**ADDENDUM
TO THE SOUTH TAHOE GREENWAY SHARED-USE
TRAIL PROJECT INITIAL STUDY/
MITIGATED NEGATIVE DECLARATION**

**FOR THE
DENNIS T. MACHIDA MEMORIAL GREENWAY
-VAN SICKLE CONNECTOR**

SCH NO. 2006112070

June 2026

Figure 2: Original Alignment and Modified Alignment for Greenway–Van Sickle Connector

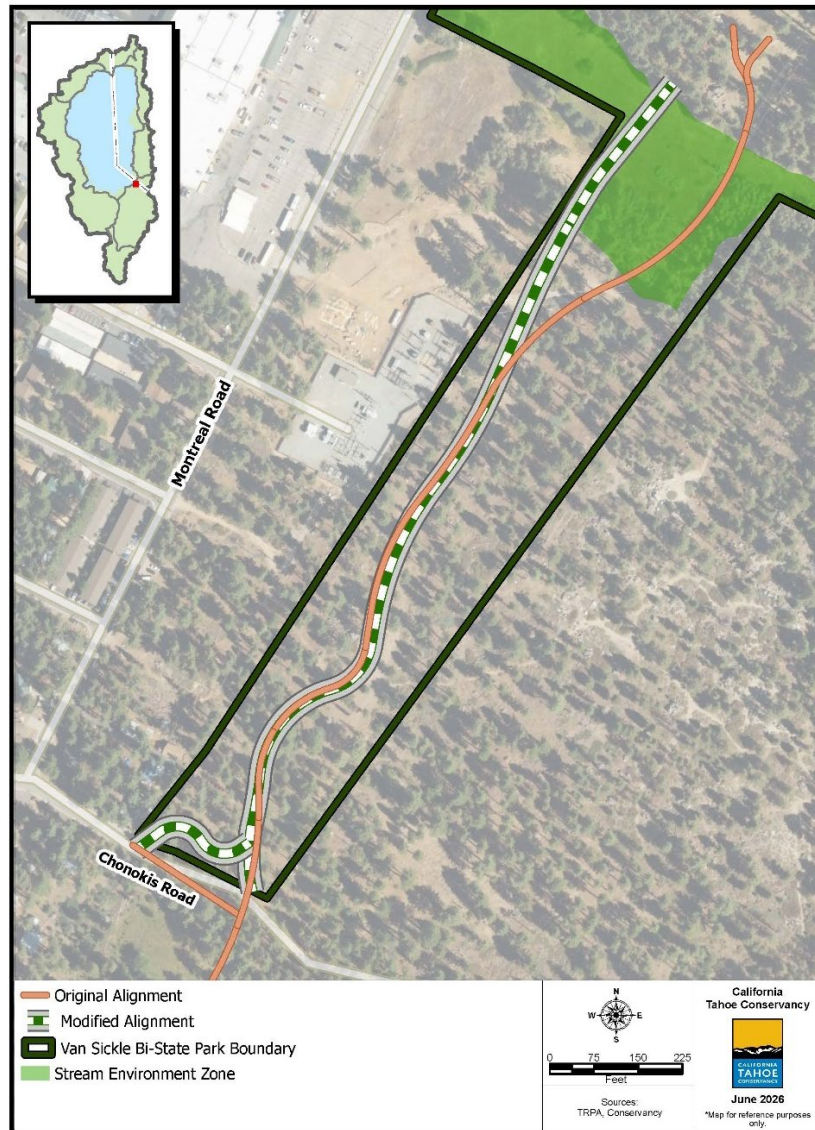
The original alignment for Phase 3 is described and depicted in Section 2.6.1.4 of the 2011 MND. **Figure 2** below shows the trail alignment as depicted in the 2011 MND and as modified by this Addendum.

Under the original alignment, the portion of Phase 3 between Chonokis Road and Van Sickle Bi-State Park was approximately 2,070 linear feet in length. This included 10-foot-wide asphalt trail on high capability land and 12-foot-wide boardwalks in two stream environment zone (SEZ) areas: (1) a 180-linear-foot boardwalk northeast of Chonokis Road, and (2) a 320-linear-foot boardwalk across the meadow south of the entrance to Van Sickle Bi-State Park (500 feet of boardwalk in total). It also included a 219-linear-feet, 8-foot-wide asphalt neighborhood connector trail to Chonokis Road.

The modified alignment for the for the Greenway–Van Sickle Connector completes the connection between Chonokis Road and the Van Sickle Bi-State Park in approximately 1,830 linear feet. Of this, approximately 1,550 linear feet will be 10-foot wide asphalt trail on high capability land, with 2-foot shoulders and 2-foot clear zones on each side. Approximately 280 linear feet will be a 13-foot-wide boardwalk to cross the SEZ near the entrance to Van Sickle Bi-

As the trail approaches the meadow south of the entrance to Van Sickle Bi-State Park, the modified alignment traverses AN 029-240-10 and onto 029-260-32 to the west of the original alignment, closer to the Liberty Utilities substation and Montreal Road, and will connect with the new shared-use trail that is proposed as part of the Van Sickle Bi-State Park Safety and Equitable Access Improvements Project. This modification reduces the length of trail in SEZ, as noted above. It also avoids conflicts between the construction equipment that will be utilized in boardwalk construction and the Liberty Utilities overhead power lines that run from the substation through Van Sickle Bi-State Park. The modified alignment will pass through the power line easement in one location but Liberty Utilities has agreed this is permissible and would not require the relocation of its electric power facilities.

The modified alignment also differs from the original alignment at the connection to Chonokis Road. The original alignment for the neighborhood connector was entirely within the City right-of-way. Modifications to this alignment are shown in **Figure 2** above and are necessary to meet ADA accessibility requirements and to minimize encroachment into the City right-of-way.
